STAFF REPORT

HISTORIC DOWNTOWN ADVISORY COMMISSION

Thursday, November 16, 2017

Architectural Elements (Page 46)

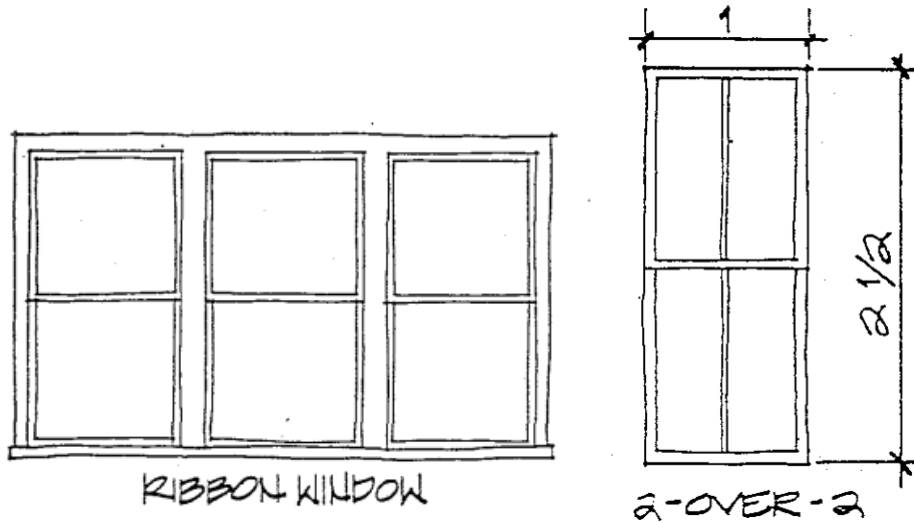
- The proposed project is somewhat in line with the PAG.
 - The front elevation of the proposal displays the Ribbon style, one of the three historically correct window styles with a 2-over-2 pattern. (Page 48)
 - Further examination by the Powell Architectural Advisor and HDAC is needed to determine whether the panels above the front windows are appropriate.

- A palette of generally darker colors with a few of the earlier, lighter colors persisting. More vivid contrast, and “picking out” of details is prevalent. (Page 73)
 - The selected green color were selected from a historic color palette and match other buildings within the downtown.
